Existing & Proposed Rear Elevation

Issue: 2
Scale 1:50 @ A3
Date: 02/08/2026
Drawn: O Joyce

Proposed

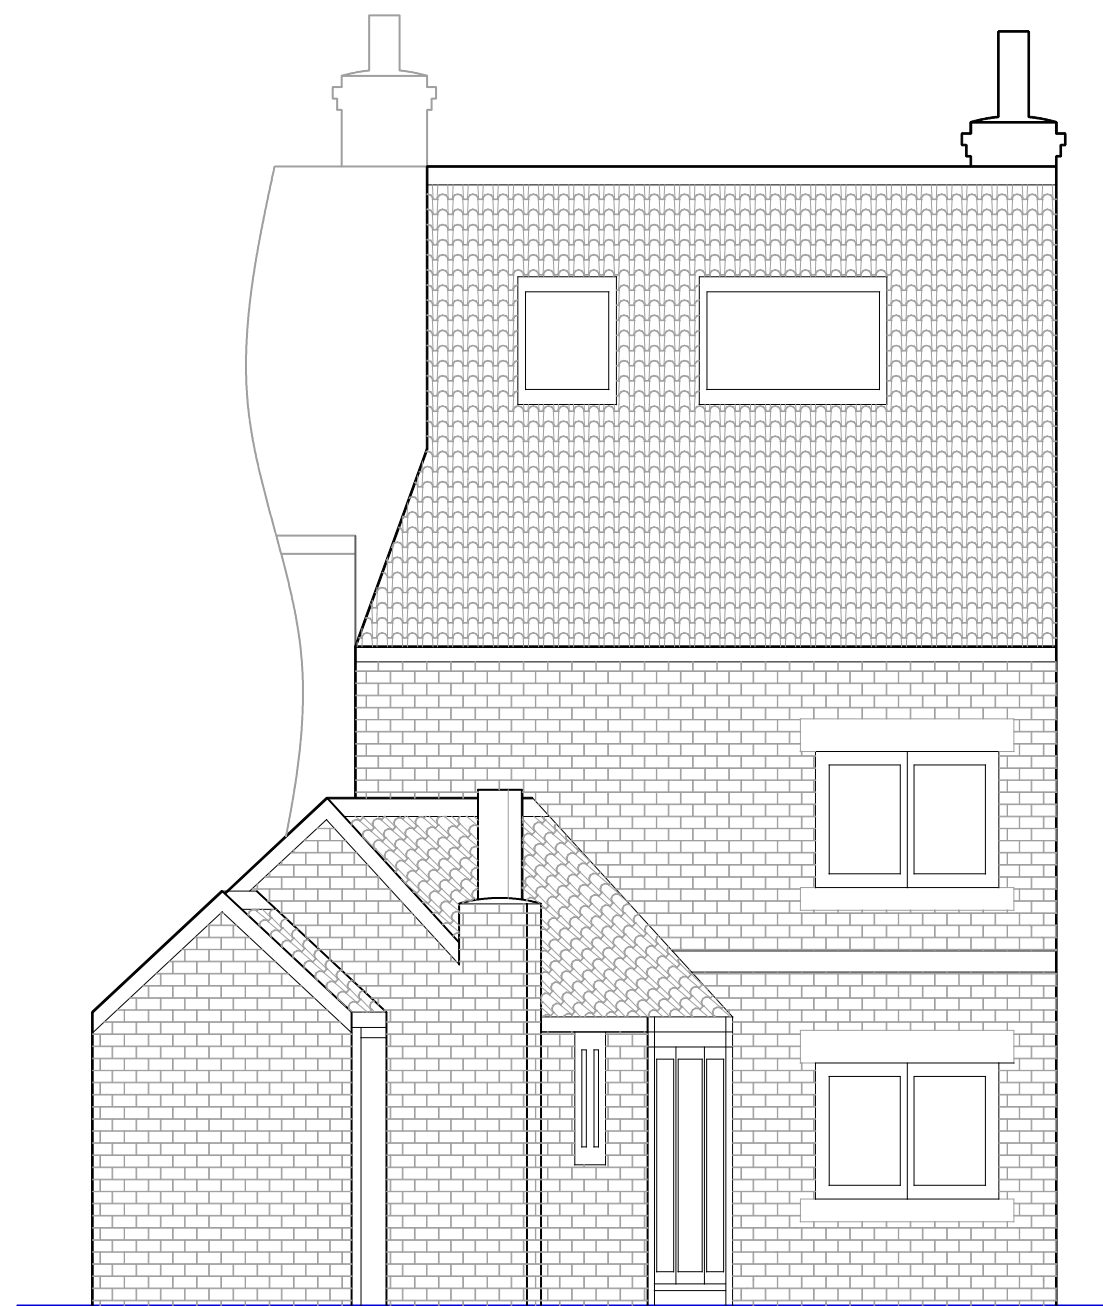
Notes:-
Drawing revised to reflect change in window sizes
